Liberty School District – Technology Remodel
Addendum No: 003
Description Narrative
November 01, 2023

ADDENDUM NO. 03

Project: Liberty | District Technology Remodel
1000 Kent Street, Liberty, MO 64068

ADDENUM No. 3

HVAC PLAN - LEVEL 1

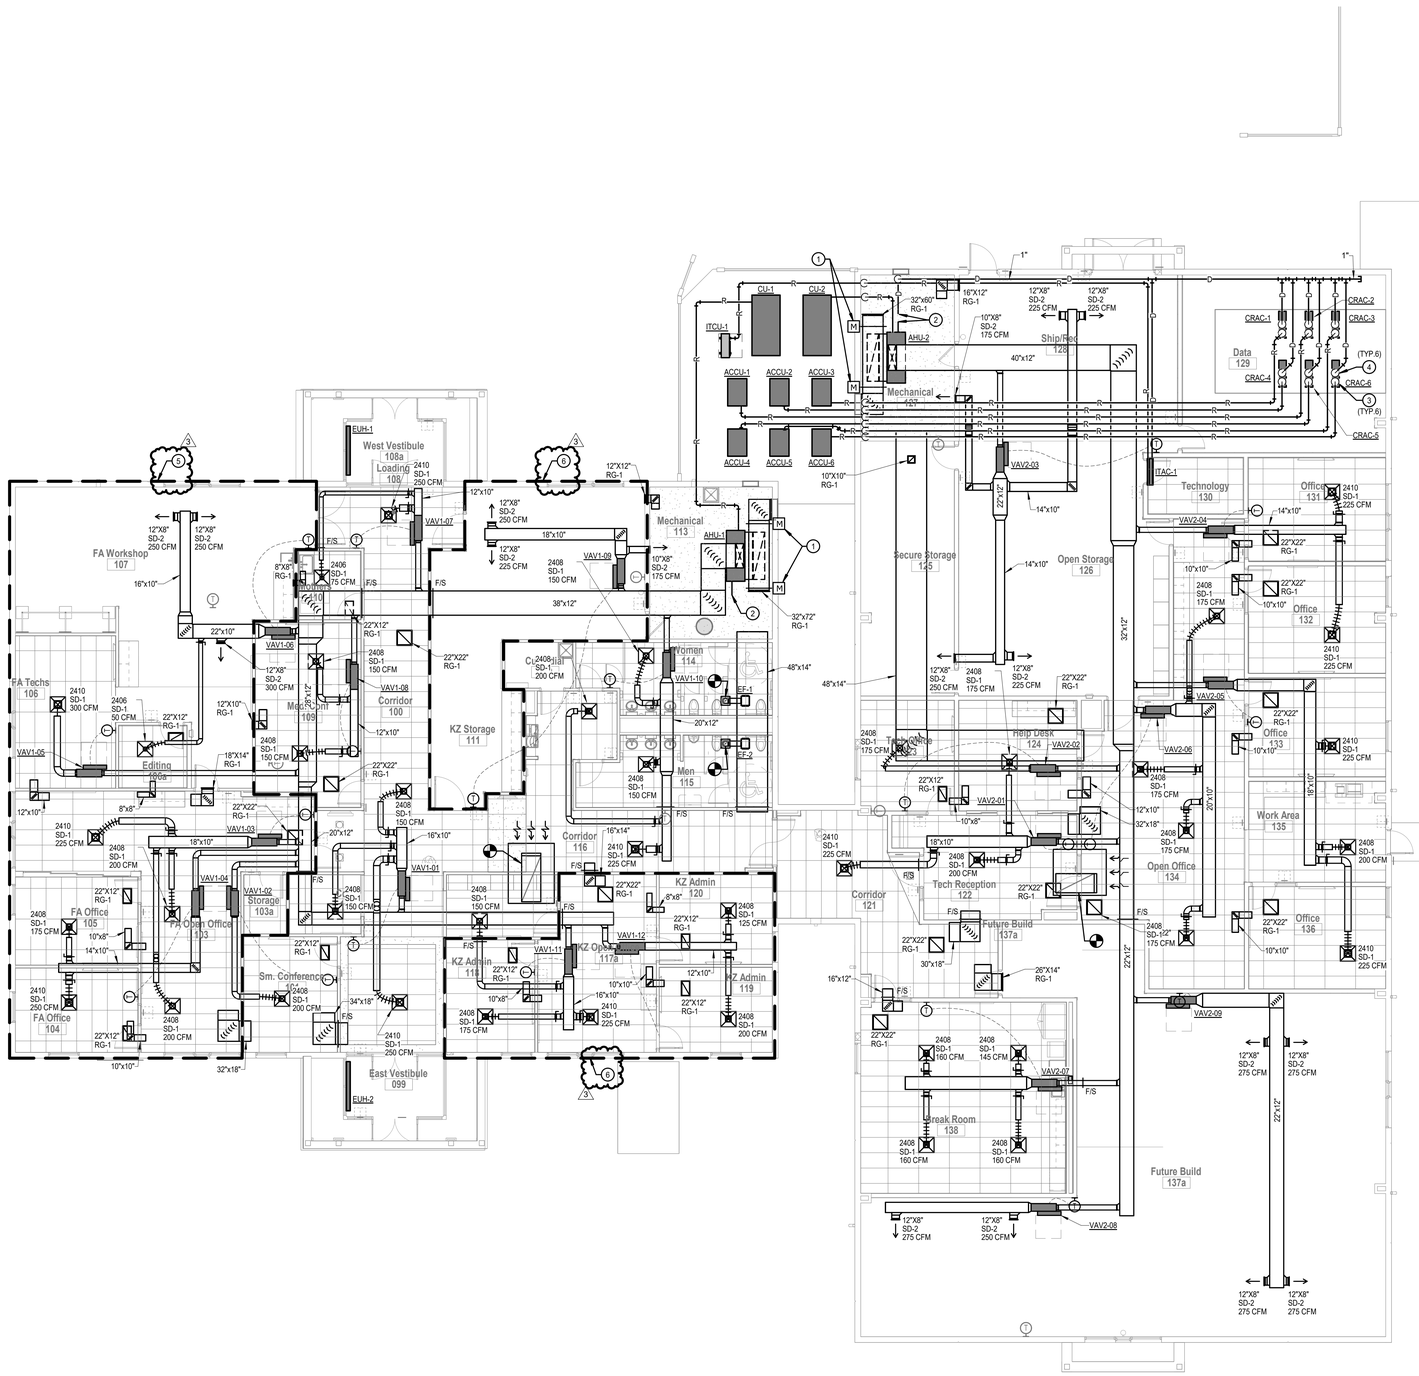
2. Sheet ME302 – MECHANICAL AND ELECTRICAL – SCHEDULES
   a. Added Ductwork Schedule, Ductwork Insulation Schedule, and Grille, Register & Diffuser Schedule.
3. Sheet M101 – HVAC PLAN – LEVEL 1
   a. Alternate scopes added.
4. Sheet P101 – PLUMBING PLAN – LEVEL 1
   a. Plan note number 6 updated.
5. Sheet E101 – LIGHTING PLAN – LEVEL 1
   a. Alternate scopes added.
6. Sheet E101 – LIGHTING PLAN – LEVEL 1
   a. Alternate scopes added.
7. Sheet E201 – POWER PLAN – LEVEL 1
   a. Alternate scopes added.
   b. Tag added to HVAC box VAV1-11.
8. Sheet LV101 – TELECOMUNICATIONS PLAN – LEVEL 1
   a. Alternate scopes added.
9. Sheet ES101 – ELECTRONIC SECURITY PLAN – LEVEL 1
   a. Alternate scopes added.
10. Sheet F101 – FIRE ALARM PLAN – LEVEL 1
    a. Alternate scopes added.
